# Product Notification Form

<b>PCN #:</b> PCN21-0021	<b>Rev:</b> 1.0	<b>Issue Date:</b> March 18, 2021
--------------------------	-----------------	-----------------------------------

**Reason for Notification:** Transport packaging change  
 minor /  major

**Packaging M.2 2242**

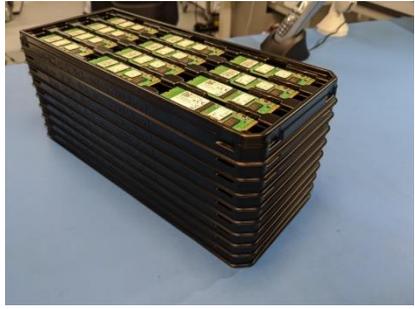
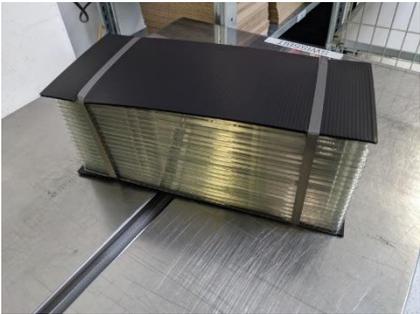
<b>Current tray packaging</b>	<b>New transport packaging</b>

Tray material	PET; transparent	PS; black
ESD safe	Yes, applied coating	Yes, permanent
Tray quantity	24 pcs ( 6x4 )	24 pcs (6x4)
Tray dimens.	136 x 323 mm	136 x 323 mm
Box quantity	20 trays x 24 pcs = 480 pcs (max.)	9 trays x 24 pcs = 216 pcs (max.)
